# Technical Service Bulletin

<b>Subject:</b>  <b>WRONG VEHICLE LOCATION IN GPS WITH DTCS B119F:01, B119F:13 AND/OR B119F:2B STORED</b>	<b>Bulletin No.:</b> 09-021/20
	<b>Last Issued:</b> 11/16/2020

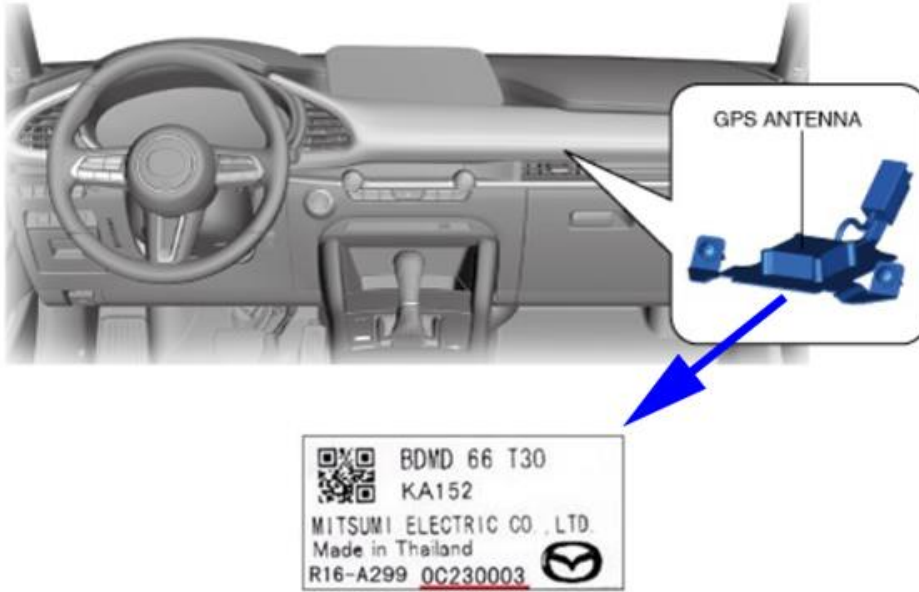
1. Verify customer concern.
2. Confirm if the telephone antenna No.1's lot number is before 0C230003. The lot number is in YMDDnnnn format.

- If the lot number is 0C230003 or later, the part is already modified.
- If the lot number is before 0C230003, replace the GPS antenna with a modified one by referring to the instructions on MGSS.
  - Mazda3: (GLOBAL POSITIONING SYSTEM (GPS) ANTENNA REMOVAL/INSTALLATION)
  - CX-30: (GLOBAL POSITIONING SYSTEM (GPS) ANTENNA REMOVAL/INSTALLATION)
